EGUSPHERE-2024-3398

Peer Review - Megill and Grewe, "Investigating the limiting aircraft design-dependent and environmental factors of persistent contrail formation".

Author Responses: First Round

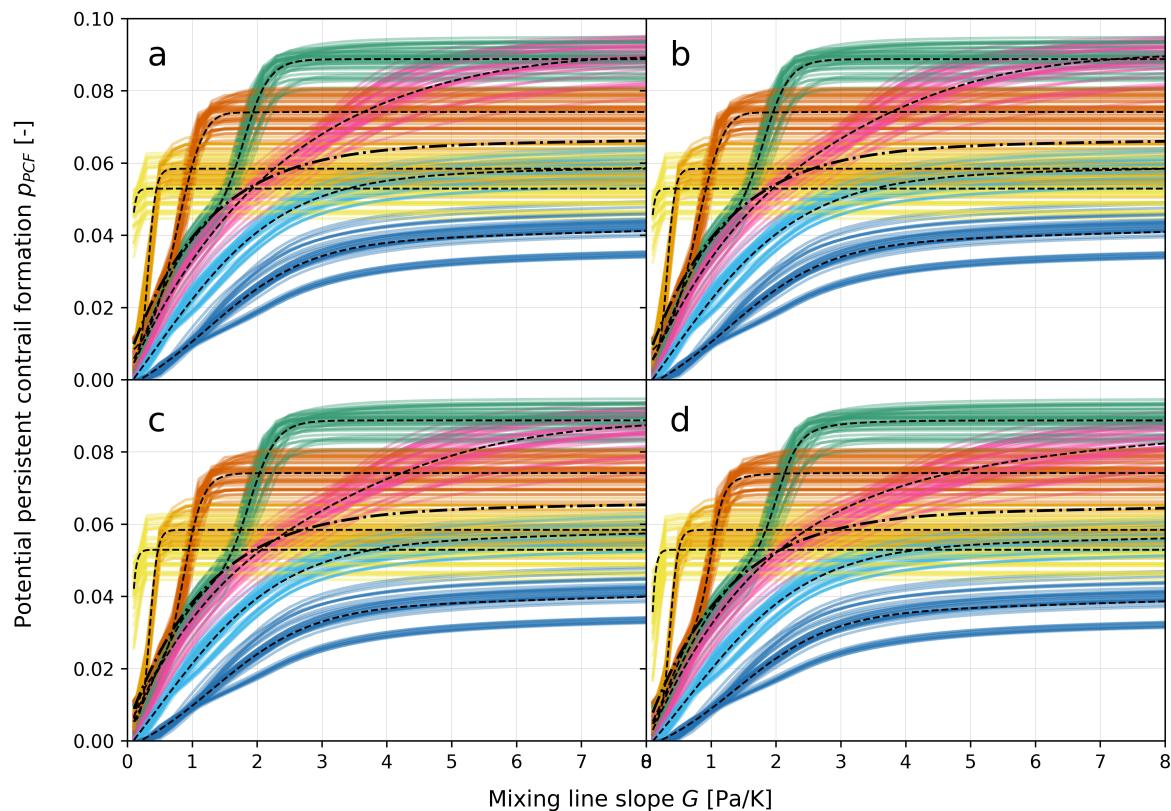
The authors investigate the limiting factors related to aircraft design and environmental conditions in the formation of persistent contrails using ERA5 data. Consistent with a previous study that reported biases in ERA5 relative humidity, the authors apply a bias correction approach to address this deficiency. However, previous studies have also reported biases in ERA5 temperature data (e.g. Wolf et al. 2023), in the upper troposphere and lower stratosphere. Since temperature is an essential parameter in the Schmidt-Appleman criterion, I recommend that the authors discuss the potential impact of these biases on their results, since they didn't correct them as in Wolf et al. (2023).

Response to R2.2: Thank you for this comment. We are aware of two previous studies that investigated the difference in ambient temperatures between ERA5 and IAGOS: Wolf et al. (2025) – the now published version of Wolf et al. (2023) – and Hildebrandt (2024). From the probability density function in Wolf et al. (2025), for example their Figure 3, we can see that ERA5 both under- and over-estimates the temperature, depending on the pressure level. For the pressure levels 250 – 200 hPa, the average difference is between -0.1 and -0.7 K, meaning that ERA5 on average underestimates the temperature in comparison to IAGOS data. Their Appendix C further shows that there is little dependence of the temperature difference on latitude and longitude. As the altitude increases (pressure level reduces), ERA5 underestimates the temperature more.

We did not initially investigate any corrections to the temperature, because we assumed that this bias would not play a big role in the results. However, following this comment, we introduced a temperature correction and re-ran the climatological potential persistent contrail formation study. We used a global increase in ERA5 temperatures of 0.1, 0.5 and 1.0 K. We are not aware of previous studies that have employed a simple global increase in temperature and note that this is a major simplification. Nevertheless, it should provide an order of magnitude understanding of what effect the bias could have on the results.

We show the results in the figure below (now also in the supplement as Figure S7) – (a) uncorrected, (b) 0.1 K increase, (c) 0.5 K increase and (d) 1.0 K increase. We find that the effect of the temperature bias is significantly lower than that of relative humidity. There is very little discernible visual difference between the uncorrected and corrected results. Most notable is the slight reduction in p_{pcf} at 250 hPa (pink).

Due to limited computational resources, we are unable to re-run the full limiting factors study with temperature corrections. If there is an effect, it will likely influence the droplet formation limiting factor at pressure levels higher than 225 hPa (altitudes below FL360). However, given the small change to the above response, we assume that the effect to the limiting factors study would also be minimal. We have included a paragraph on ambient temperature corrections in Section 2.4 (ln. 218-224).

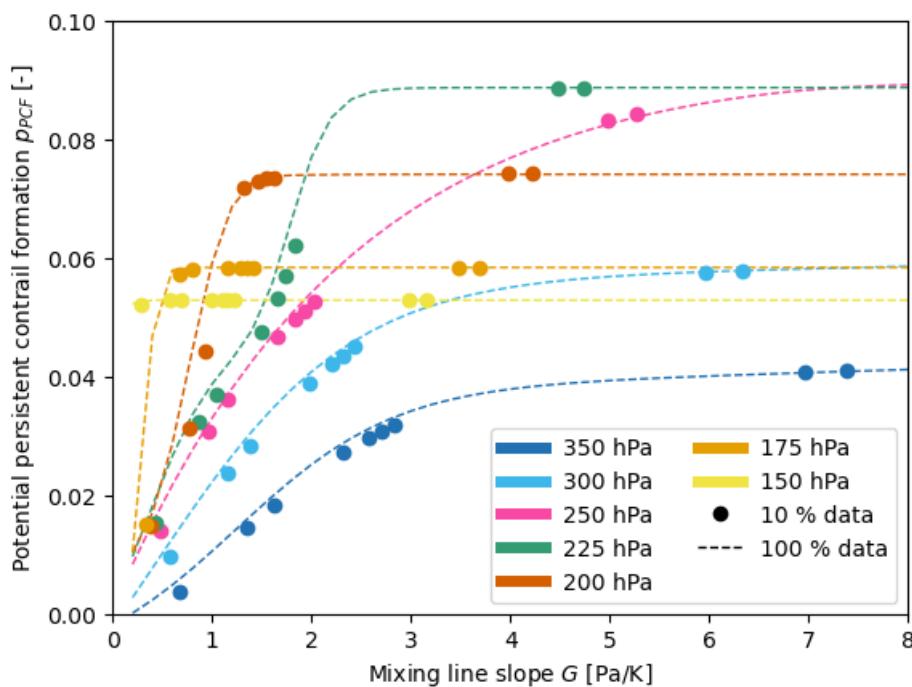
The authors conducted their study over the decade of 2010. To limit computational costs and reduce autocorrelation, they randomly selected 10 % (one-year duration data) of the total data. It is questionable whether the study can be considered a climatological framework study, especially at the regional scale, where the limited number of sampling points may raise concerns about statistical robustness. The authors should perform a sensitivity test on the sample size (number of hours or percentage) to assess the robustness of the results (e.g., variation in the fraction of persistent contrails with fuel change) and the conclusions of the study.

Response to R2.3: For the limiting factors study, we use 10% of all hours within the 2010 decade. On average, therefore, we consider full global data every 10 hours, which we believe is more than sufficient for a climatological study.

We have performed a further analysis to ensure that this is indeed the case. Since the climatological response functions (Figure 7) are significantly less computationally intensive, they are based on *all* hours within the 2010 decade. therefore, we can plot the potential persistent contrail formation for each aircraft in the limiting factors study, using 10% of the data, on top of the fitted responses in Figure 7 - see the figure below. Showing all seasonal values would be too cluttered for this analysis.

We can clearly see that the results using only 10% of the data (circular markers) closely resemble the full results (dashed lines). We also note that the dashed lines correspond to the fits (not the average) and thus a difference can be expected. We therefore believe that 10% of the data is sufficient for a climatological study.
